ADDENDUM

Project Name: Lighting Fixture Replacement for: Payson CUSD #1

Project Number: 5785

Addendum Number: 01

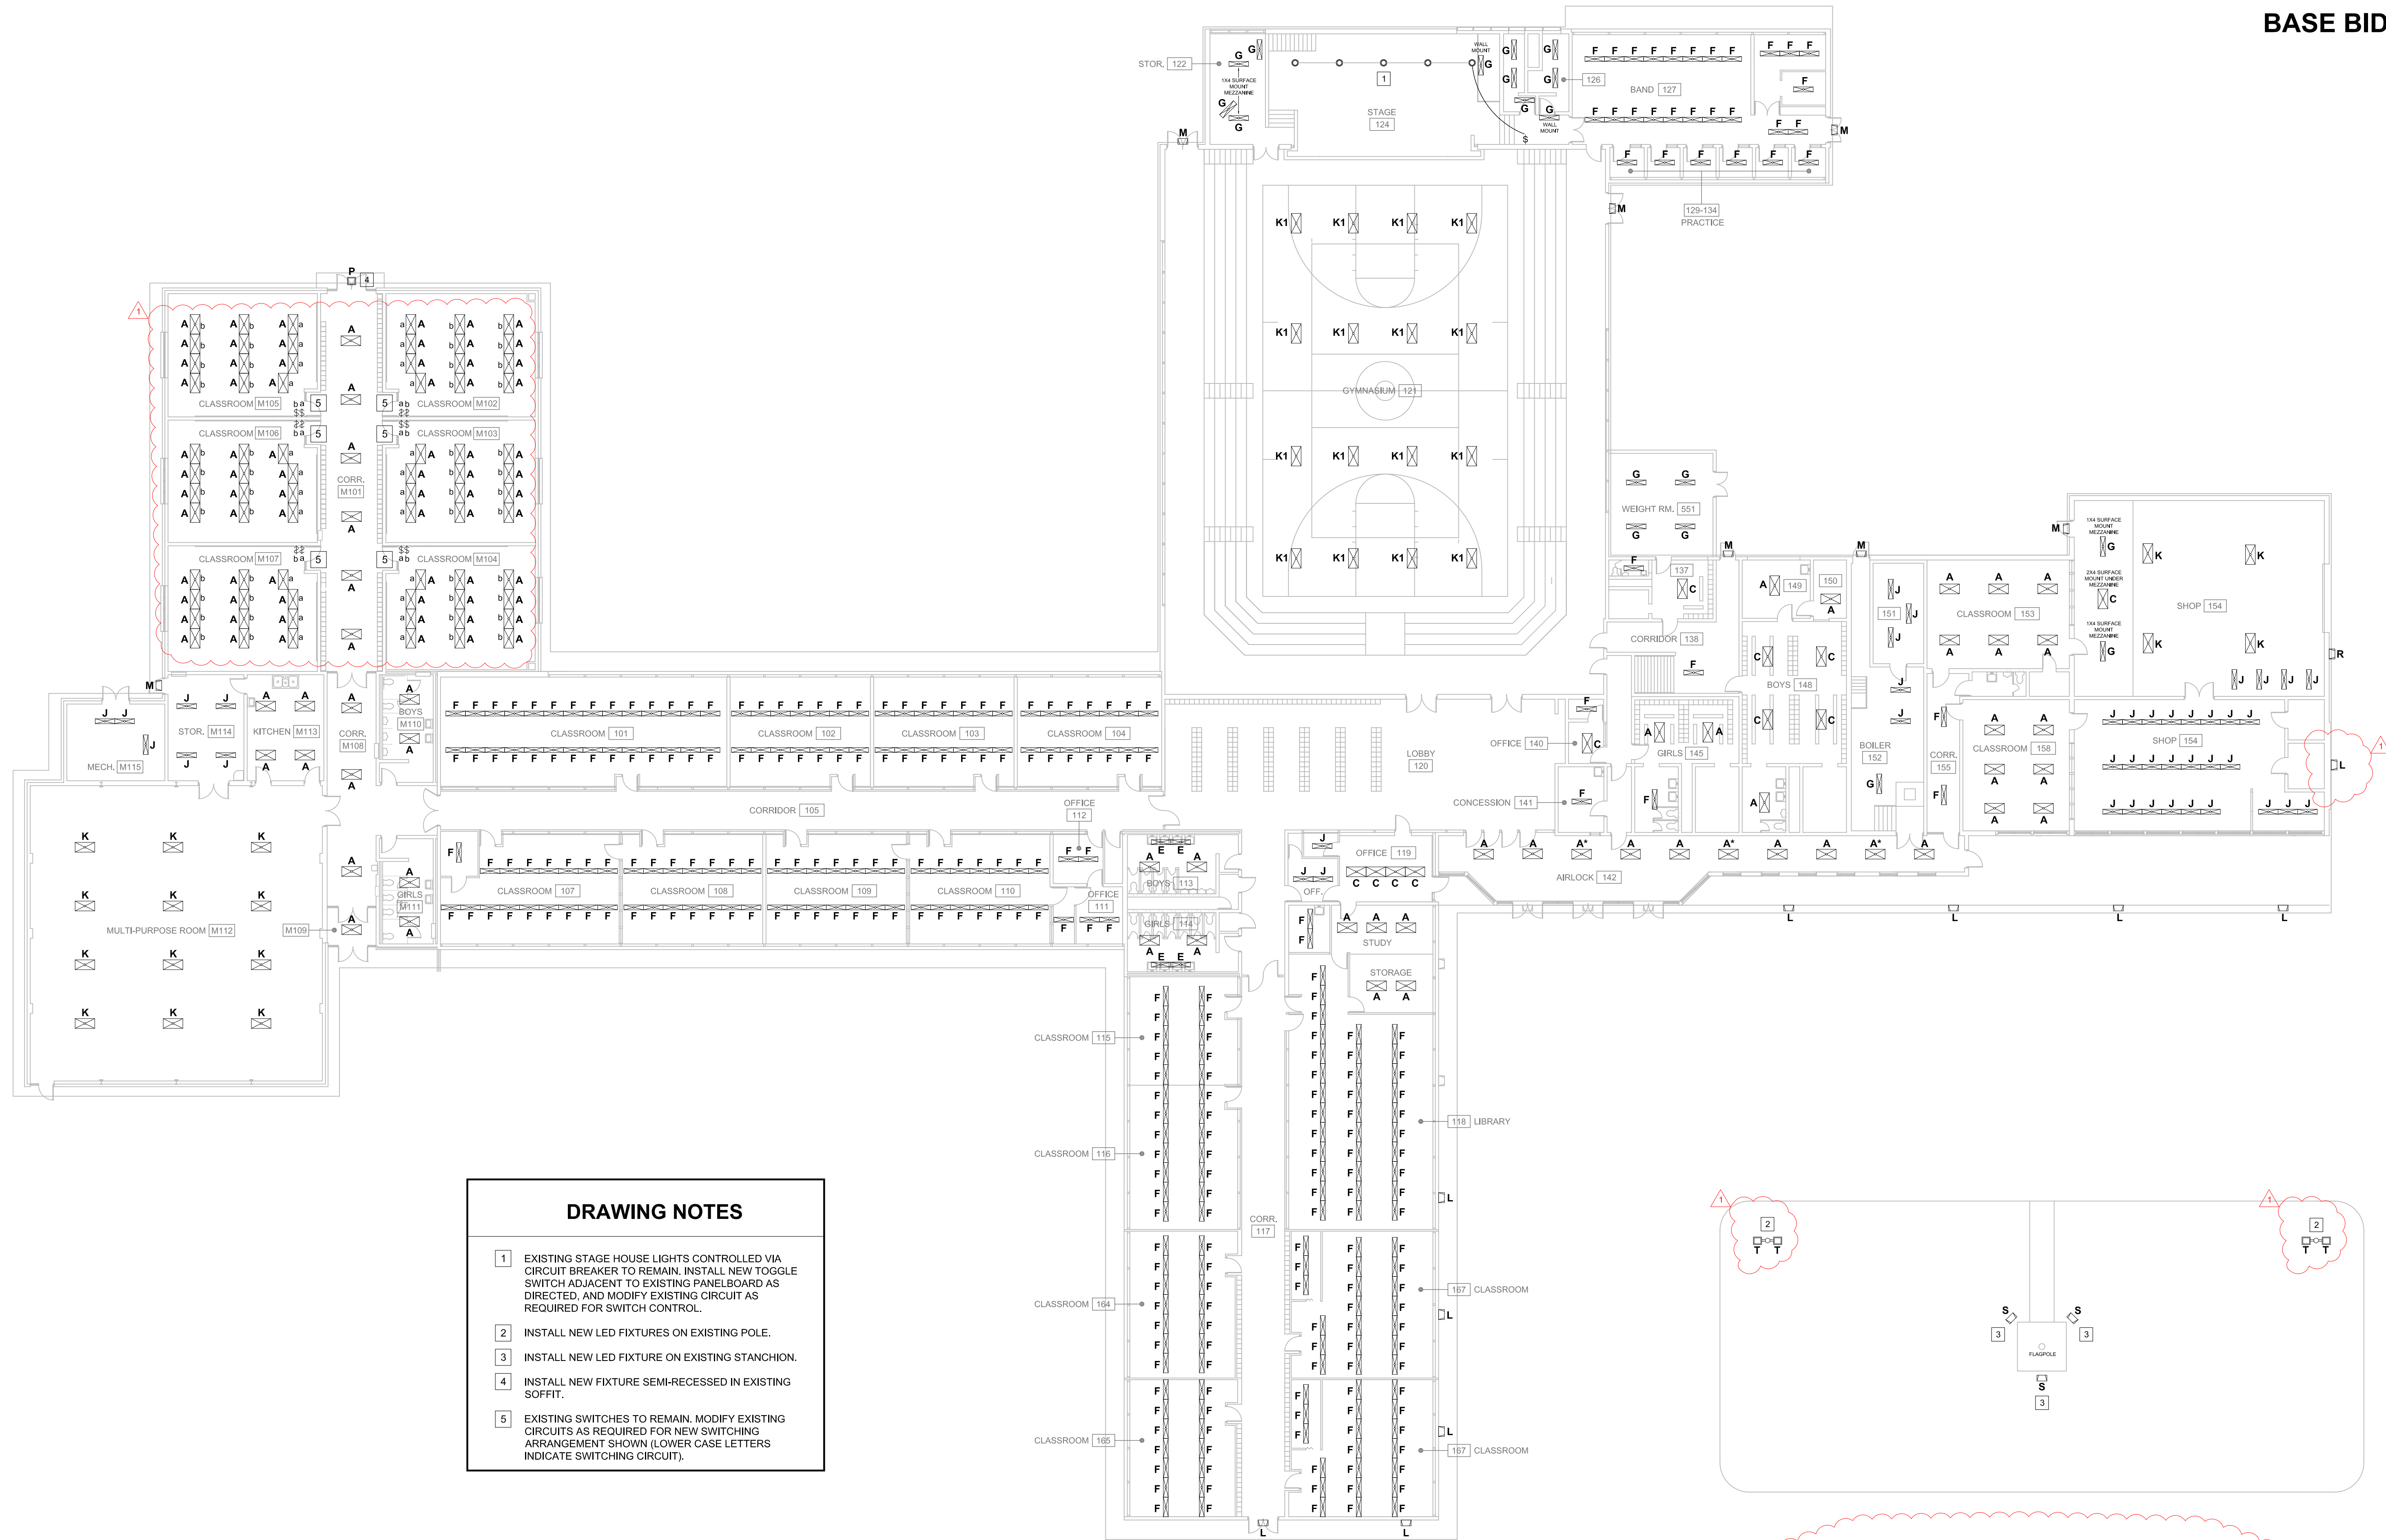
E1	Revise	See attached revised drawing Added exterior parking lot fixtures to be replaced as part of this contract
E2	Revise	See attached revised drawing Revised exterior parking lot fixture "T" quantities Added notes regarding lighting switch circuit modifications Add additional Fixture "E"

- 1 EXISTING STAGE HOUSE LIGHTS CONTROLLED VIA CIRCUIT BREAKER TO REMAIN. INSTALL NEW TOGGLE SWITCH ADJACENT TO EXISTING PANELBOARD AS DIRECTED, AND MODIFY EXISTING CIRCUIT AS REQUIRED FOR SWITCH CONTROL.
- 2 INSTALL NEW LED FIXTURES ON EXISTING POLE.
- 3 INSTALL NEW LED FIXTURE ON EXISTING STANCHION.
- 4 INSTALL NEW FIXTURE SEMI-RECESSED IN EXISTING SOFFIT.
- 5 EXISTING SWITCHES TO REMAIN. MODIFY EXISTING CIRCUITS AS REQUIRED FOR NEW SWITCHING ARRANGEMENT SHOWN (LOWER CASE LETTERS INDICATE SWITCHING CIRCUIT).

NOTE:
FOUR EXISTING POLE MOUNTED FIXTURES LOCATED ON SOUTH SIDE OF PARKING LOT AND TWO EXISTING POLE MOUNTED FIXTURE LOCATED ON EAST SIDE OF PARKING LOT SHOWN HERE ON PLAN (NOT TO SCALE - VERIFY IN FIELD). REPLACE EXISTING FIXTURES WITH NEW LED FIXTURES TYPE "T" INSTALLED ON EXISTING POLES. VERIFY HEAD LOCATIONS AND COORDINATE REQUIRED BRACKETS BEFORE SUBMITTING SHOP DWGS.
